ADDENDUM NO. 3

**FOR THE CONSTRUCTION OF THE
SUNY BROOME CULINARY ARTS CENTER**

**78 Exchange Street
Binghamton, NY 13905**

Tiered Demo Kitchen Shade Power - E-SK-09

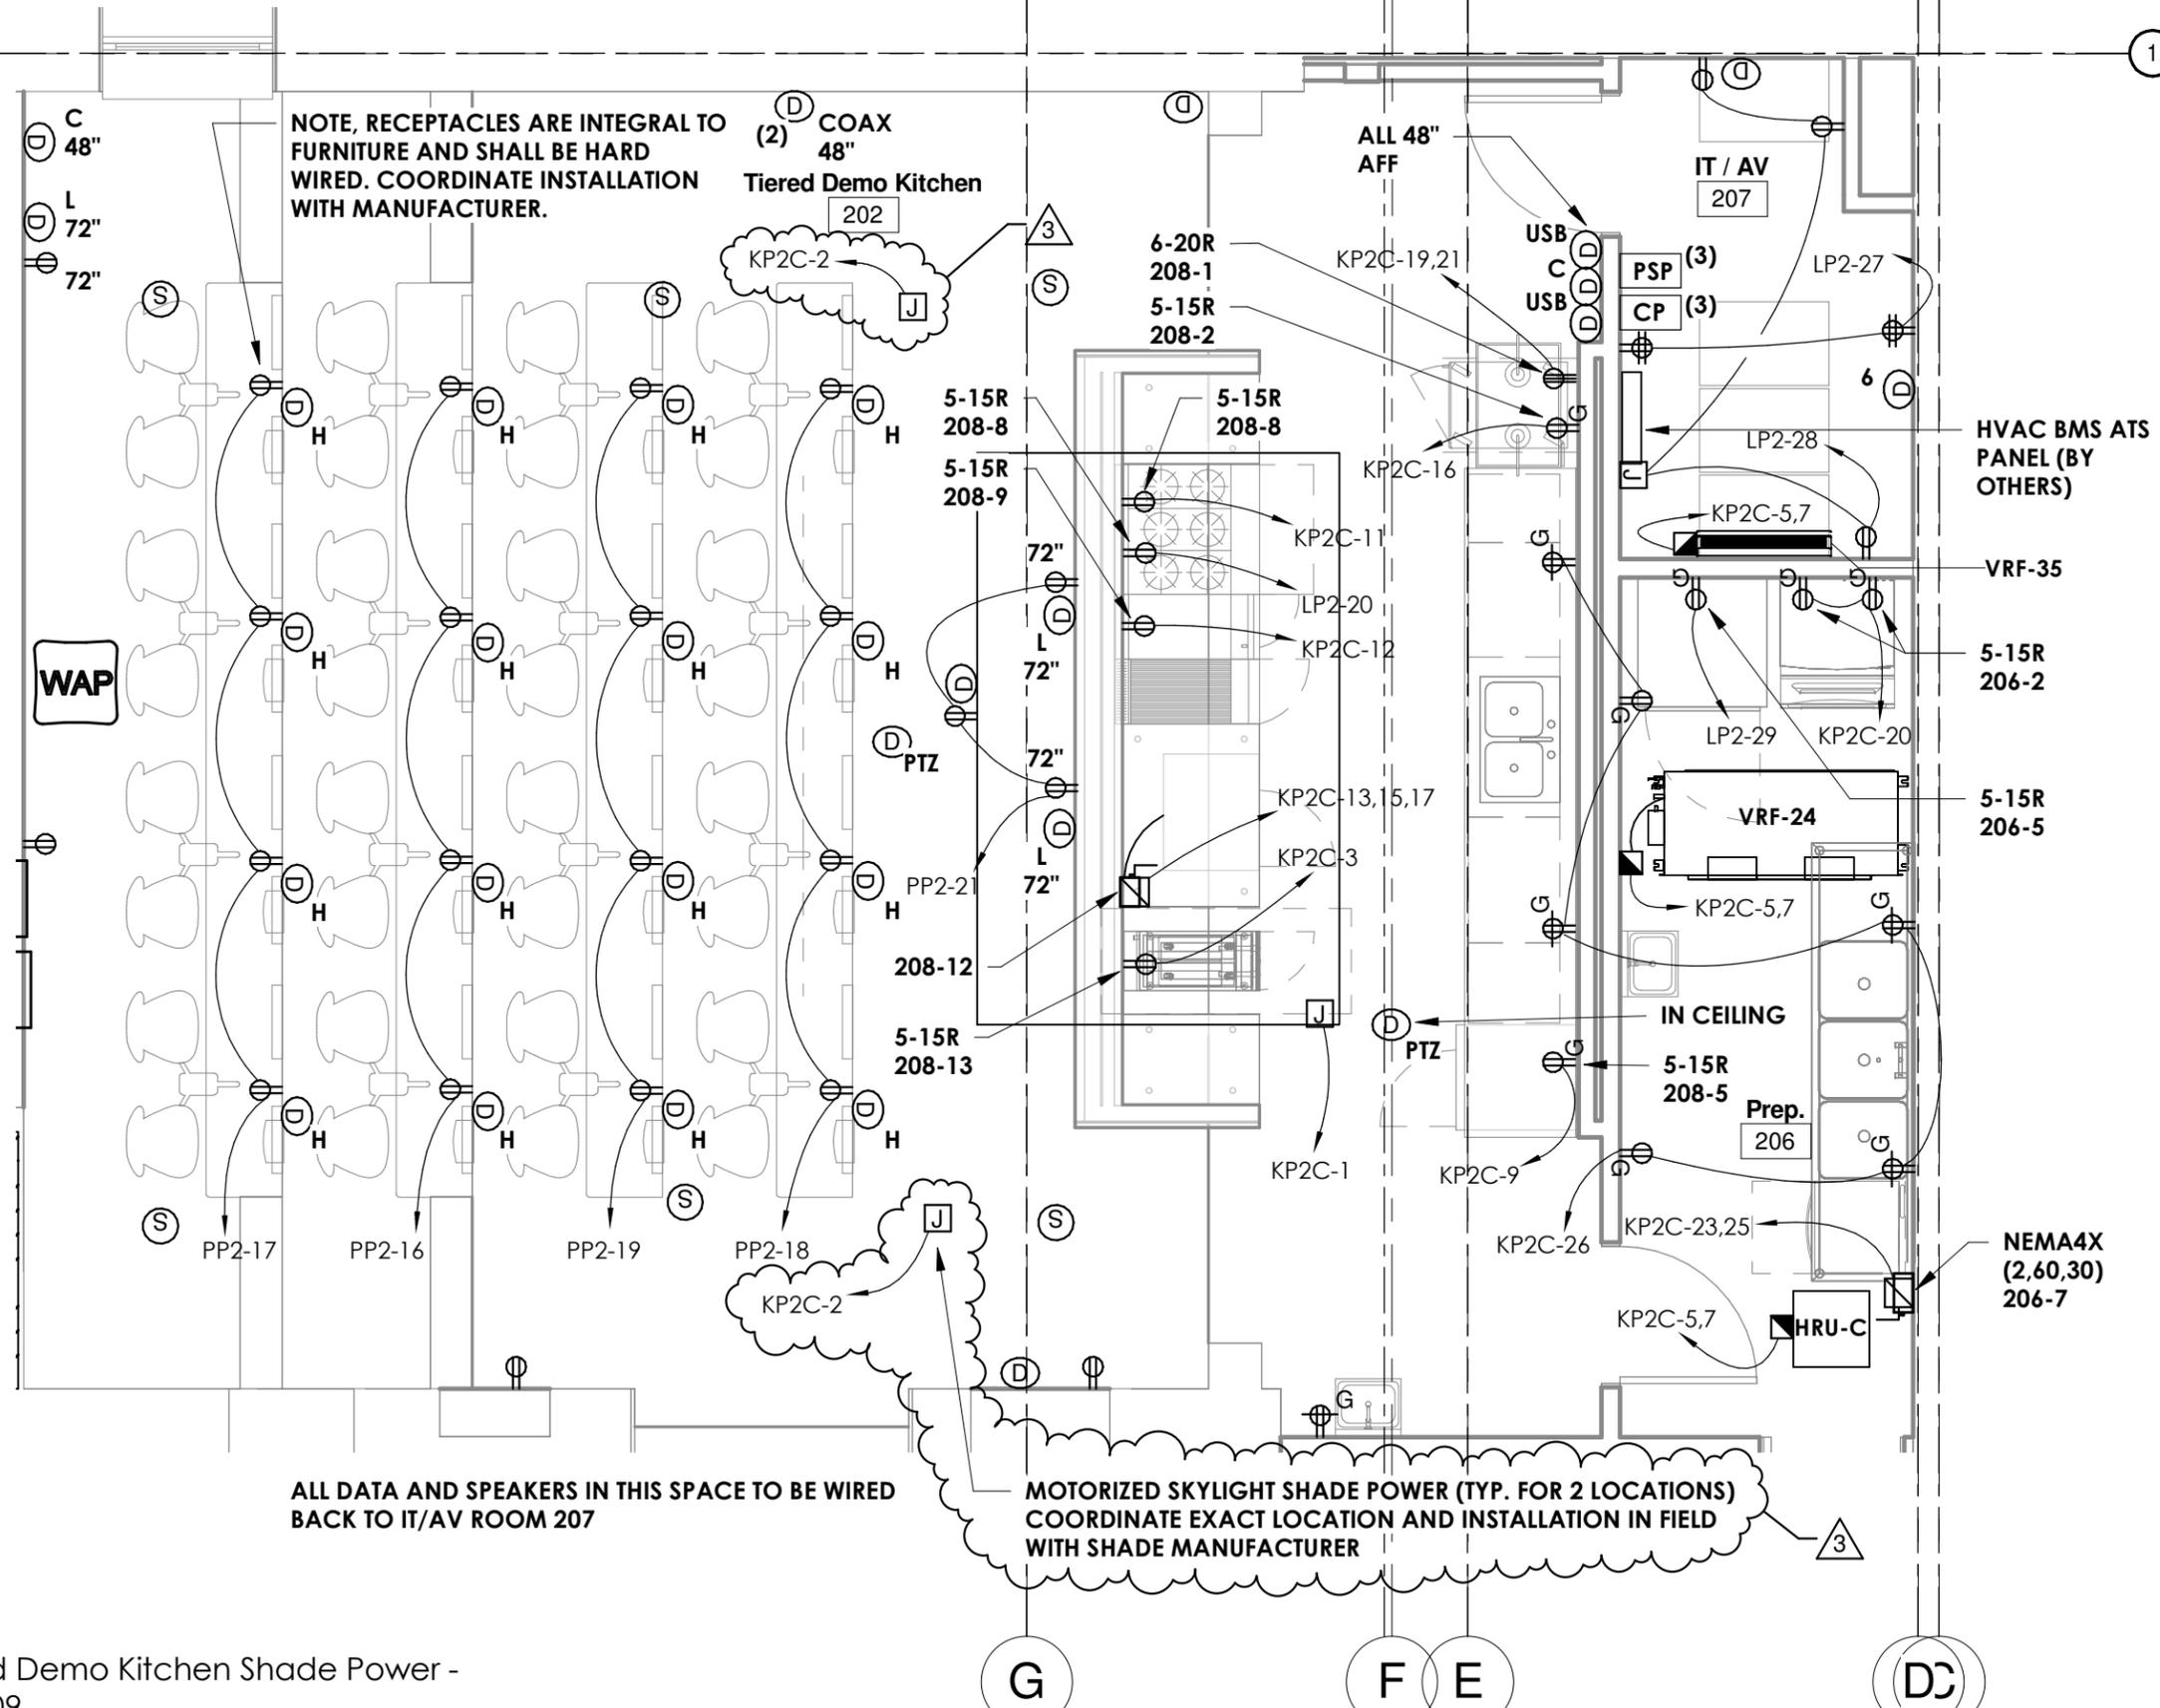
1. Drawing Sheet E-402:
 - a. Revise the Tiered Demo Kitchen Enlarged Plan per E-SK-09.
2. Drawing Sheet M-002: Please change the following VRF Outdoor Unit Selections to the following:

MOTORIZED SKYLIGHT SHADE POWER (TYP. FOR 2 LOCATIONS) COORDINATE EXACT LOCATION AND INSTALLATION IN FIELD WITH SHADE MANUFACTURER
